To: Planning Committee **Date:** June 5, 2023
From: Wayne Craig
Director, Development **File:** RZ 18-843479
Re: **Revised Rezoning Considerations for the Application by Sian Group Investments Inc. for Rezoning at 7100 and 7120 Ash Street from the “Single Detached (RS1/F)” Zone to the “Town Housing (ZT16) - South McLennan and St. Albans Sub-Area (City Centre)” Zone**

1. That third reading of Richmond Zoning Bylaw 8500, Amendment Bylaw 10163, for the rezoning of 7100 and 7120 Ash Street, be rescinded and the associated Rezoning Considerations be revised to reflect changes to tree retention and replacement, as per Attachment D to this report; and
2. That Richmond Zoning Bylaw 8500, Amendment Bylaw 10163, for the rezoning of 7100 and 7120 Ash Street from the “Single Detached (RS1/F)” zone to the “Town Housing (ZT16) - South McLennan and St. Albans Sub-Area (City Centre)” zone, be granted third reading.

Sian Group Investments Inc. has applied on behalf of the owner, 1199445 BC Ltd. (Sukhinder Kaur Sian), to rezone 7100 and 7120 Ash Street from the “Single Detached (RS1/F)” zone to the “Town Housing (ZT16) - South McLennan and St. Albans Sub-Area (City Centre)” zone to permit the deve

DRAWING TITLE
LANDSCAPE PLAN

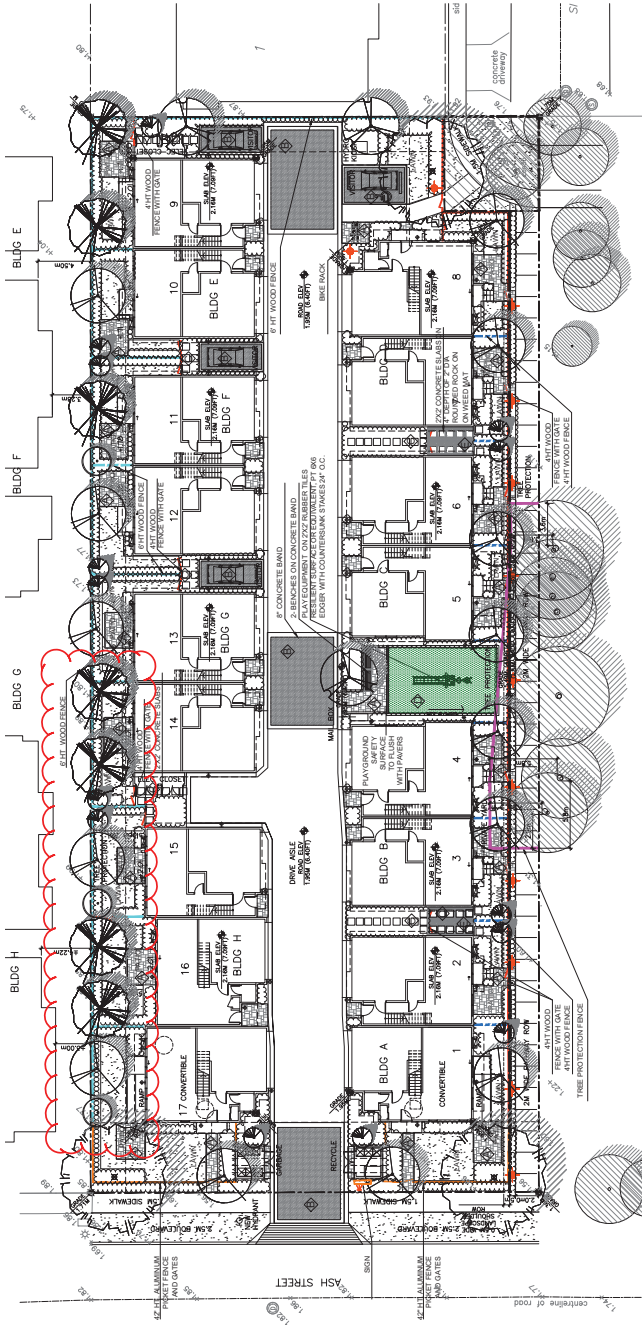
The proposed revised Landscape Plan illustrates that 10 trees are to be located along the north side of Buildings H and G, in the area where the four trees are proposed to be removed (i.e., two 3.5 m high Slender Serbian Spruce, two 9 cm caliper Green Pillar Pin Oak, two 8 cm caliper Pink Star Magnolia, and four 11 cm Chanticleer Pear). The proposed revised Landscape Plan is desirable as it provides some visual interest and screening along the interface with existing town housing to the north.

- remove Trees # 364-367 and the associated tree survival security;
- provide eight additional replacement trees, for a total of 44 replacement trees; and
- enable the Landscaping Security associated with the DP to be increased to account for the additional replacement trees (based on a cost estimate provided by the registered Landscape Architect prior to DP issuance).

DRAWING TITLE:
TREE MANAGEMENT PLAN

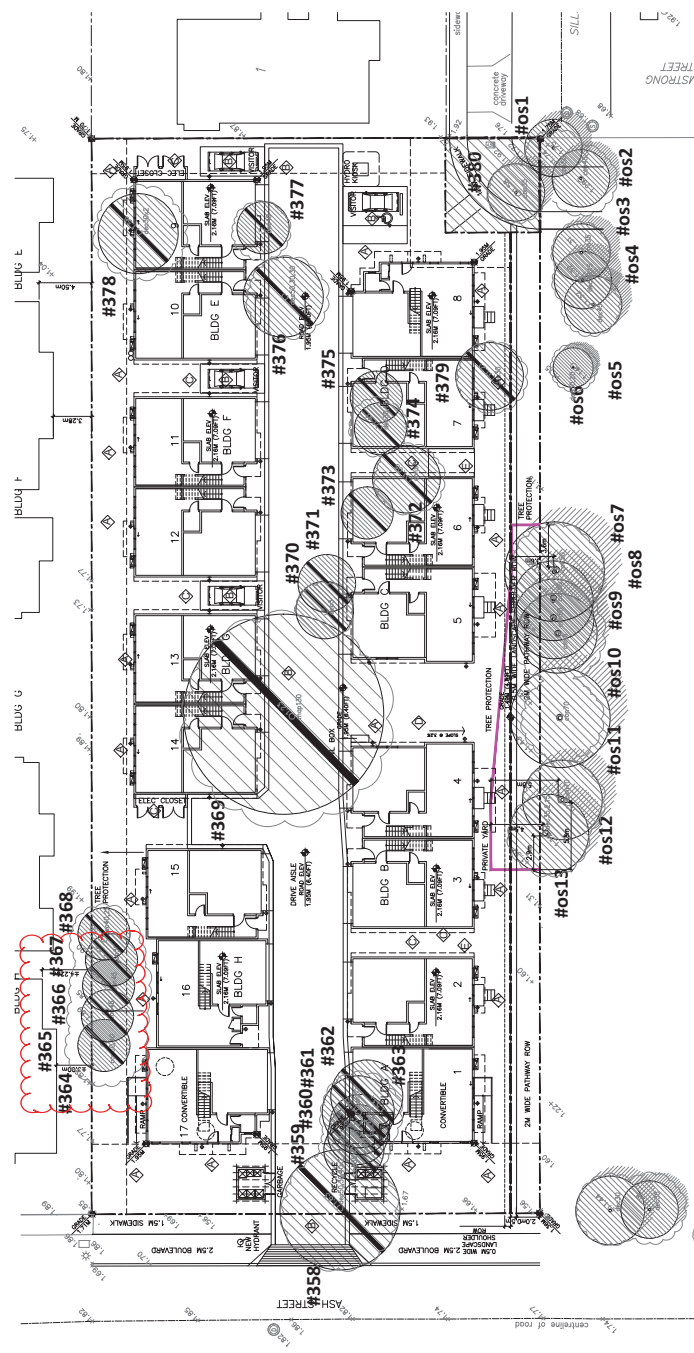
The proposed revisions to the Site Plan, Landscape Plan and Tree Management Plan are included in Attachment C, which shows the location of the four trees proposed to be removed (Trees # 364-367) and the additional eight replacement trees proposed to be planted throughout the site for a total of 44 replacement trees.

As the protected trees are not going to survive, we would like to apply to remove the tree retention (tag 364 – 367) in the rezoning consideration.
